SUNDRY NOTICES AND REPORTS ON WELLS

1. Type of Well								
✓ Oil Well Gas Well Other					8. Well Name and No. DUNCAN FEDERAL #3			
2. Name of Operator JALAPENO CORPORATION					9. API Well No. 30-005-63564			
3a. Address PO BOX 1608 3b. Phone No. (include area code)					10. Field and Pool or Exploratory Area			
ALBUQUERQUE, NM 87103 (505) 242-2050					WOLF LAKE SAN ANDRES SOUTH

<u>Duncan Federal #3</u> 330' FSL & 330' FWL Sec 7, T9S-R28E Chaves, New Mexico

## Duncan Federal 3 30-005-63564 Jalapeno Corporation June 20, 2019 Conditions of Approval

**TOG Surface** 12 1/4" hole 8 5/8" 28# casing. 470 sks cement circulated to surface. 549' 7 7/8" hole, 5 1/2" casing set to 2307' Cement top 1350' 180 sks Perf 2217'-2228' 14 shots Perf 2245'-2278' 17 shots PBTD = 2286'TD = 2307' API: 30-005-63564 Before Plug & Abandonment

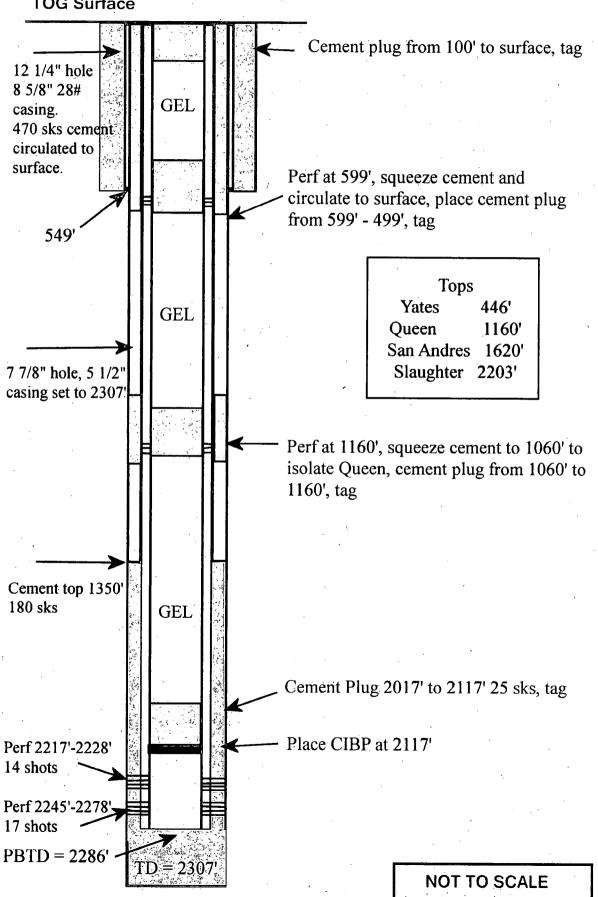
- 1. Operator shall place CIBP at 2,117' (50'-100' above top most perf) and places 25 sx of Class C cement on top as proposed. WOC and TAG.
- 2. Operator shall perf and squeeze at 1,160' as proposed. Operator shall place a balanced Class C cement plug from 1,160-1,060' as proposed.
- 3. Operator shall perf and squeeze as proposed at 599'. Operator shall place a balanced Class C cement plug from 599'-350'as proposed to seal the 8-5/8'' casing shoe and the Yates Formation. WOC and TAG.
- 4. Operator shall perf and squeeze as proposed at 200'. Operator shall place a balanced Class C cement plug from 200' to surface to isolate the Salt Formation.
- 5. See Attached for general plugging stipulations.
